**Caroline County
Board of Supervisors Agenda
Executive Summary**

Title: **Consent Agenda – Proposed Revisions to First Responders
Monument Paver Guidelines and Symbols on Monument Stone
to Include Sheriff’s Office**

REVISED 3/4/20

PROPOSED GUIDELINES FOR FIRST RESPONDER MOMUMENT PAVERS

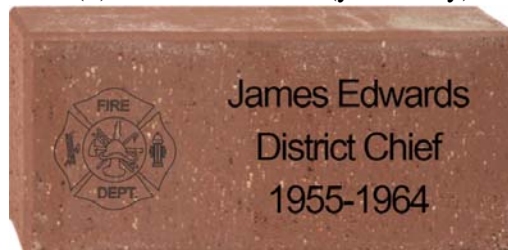
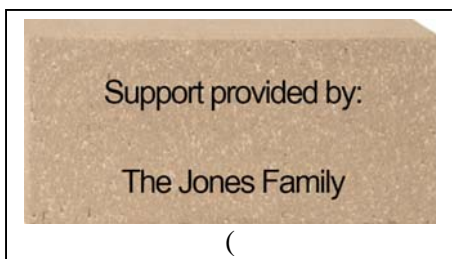
Also attached is a revised mockup of the monument stone to include Sheriff Lippa's Sheriff and E-911 Communications symbols, which the Sheriff has also approved. At Supervisor Long's request, the Fire and EMS related symbols have been changed from the version provided for the February 11th Board meeting to the version included in the Board packet.
